RE: **Lot 12 Block 4 Volcano Cliffs Unit 19 SAD 228
6511 Vista Del Prado NW
Grading and Drainage Plan
Engineers Stamp Date: 11/6/2023 (D10D003T12)**

DRAINAGE AND TRANSPORTATION INFORMATION SHEET (DTIS)

Date (09/28/2444)		Drawn By: COE		Scale: 1/16" = 1'-0"
DATE	REVISION	DESIGNED BY: PWC	DRAWN BY: COE	DATE: NOV 2023
LOT 12, BLOCK 4, VOLCANO CLIFFS, UNIT 19 ALBUQUERQUE, BERNALILLO COUNTY, NM		6511 VISTA DEL PRADO, NW		FILE #: G/D
Grading & Drainage Plan		1 OF 1

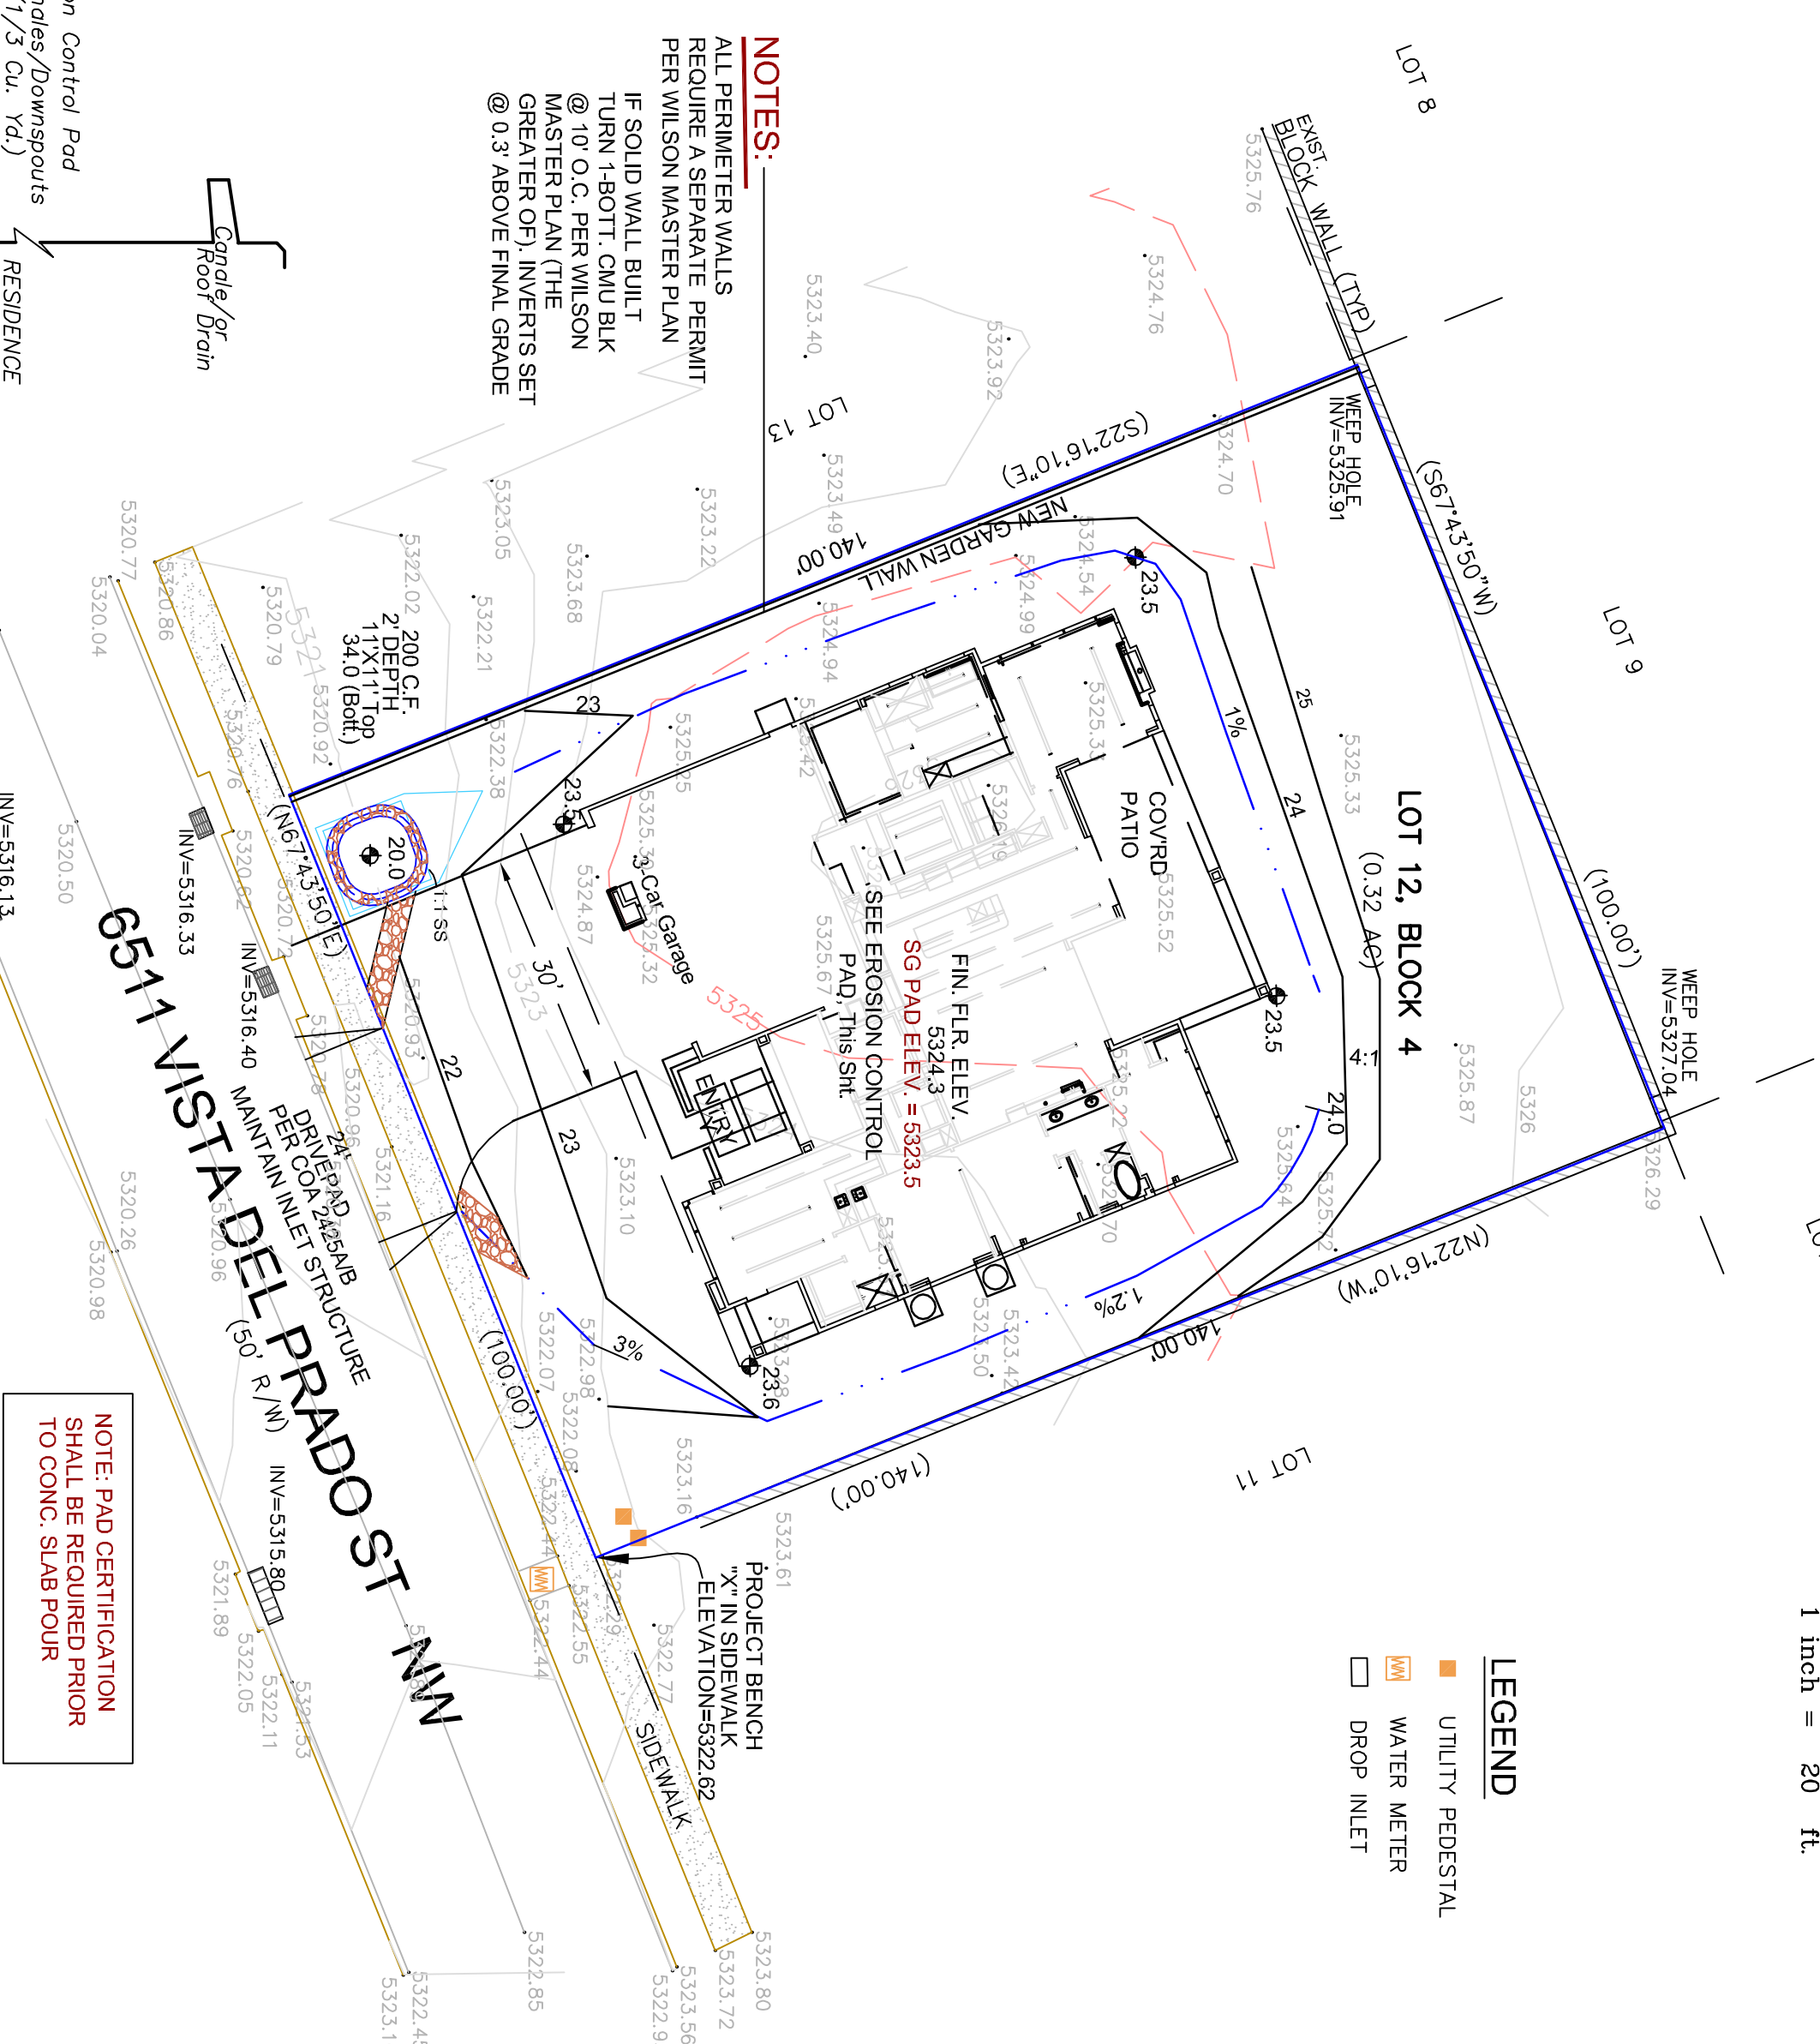
Based upon the information provided in your submittal received 11/7/2023, this plan is approved for grading permit. **Prior to Building permit approval, a Pad Certification will be required, provided by the Engineer or a registered Land Surveyor.**

Advise the owner contractor not to use dirt as a ramp to climb the curb, use lumber or crusher fines for this purpose. Place this note on the plan.

Reiterate to the Owner/Contractor that a separate permit for a garden/retaining wall must be obtained with the approved G&D plan and Pad Certification. Also, if a swimming pool is to be placed after this approval a new grading and drainage plan will need to be resubmitted showing the changes for the land treatments.

Prior to Certificate of Occupancy release, Engineer Certification per the DPM checklist is required.
